**RURAL ELECTRIFICATION CORPORATION LIMITED**  
**IT Division**  
**CORPORATE OFFICE**

**TENDER NO: REC/IT/93(S)/05/-ERP/SERVER/1 DATED 19th JANUARY, 2008**

**Supply, Installation, Configuration, Testing, Commissioning, Training, Maintenance and System Integration of Servers, various Equipments and/or Products and on-site Facilities Management for ERP at RECL, Corporate Office, Core 4, Scope Complex, Lodi Road, New Delhi – 110 003**

**PRE-BID CLARIFICATION/MODIFICATION**

### Data Centre Logical Diagram

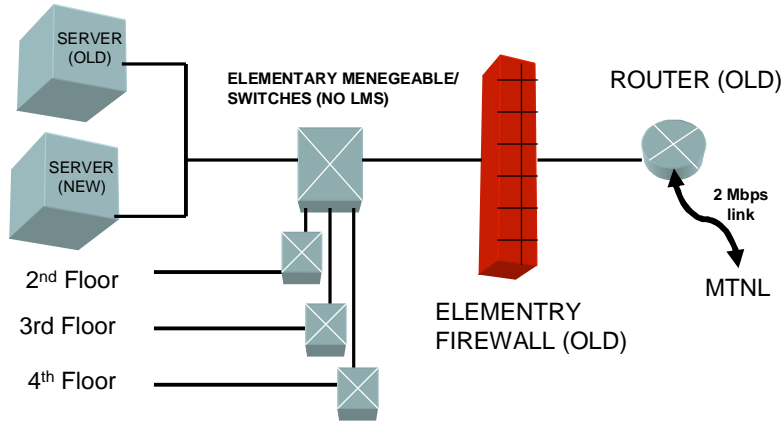
31	Serial 20 - LTO Tape library – number of drives  Page - 122	4 extendable to 6 with multi streaming , multiplexing and for restore to optimize the drives scalable up to 18/12  Specification scalability is not clear. Please specify scalability is 6,12 or 18	The complete revised Tape Library specification is given in enclosed annexure with this corrigendum.
32	Serial 20 - LTO Tape library – number of tape cartridges  Page - 122	Minimum 30/15 scalable up to 80/40. Slots requirement is not clear from this. Please clarify	The complete revised Tape Library specification is given in enclosed annexure with this corrigendum.
33	Logical diagram Page - 95	What does SA mean in the logical diagram	Modified diagram is enclosed in annexure with this corrigendum.
34	Logical diagram Page - 95	As the database server has to be in HA mode , both the server should be connected to SAN switch and in turn SAN box should be connected to	Modified diagram is enclosed in annexure with this corrigendum.
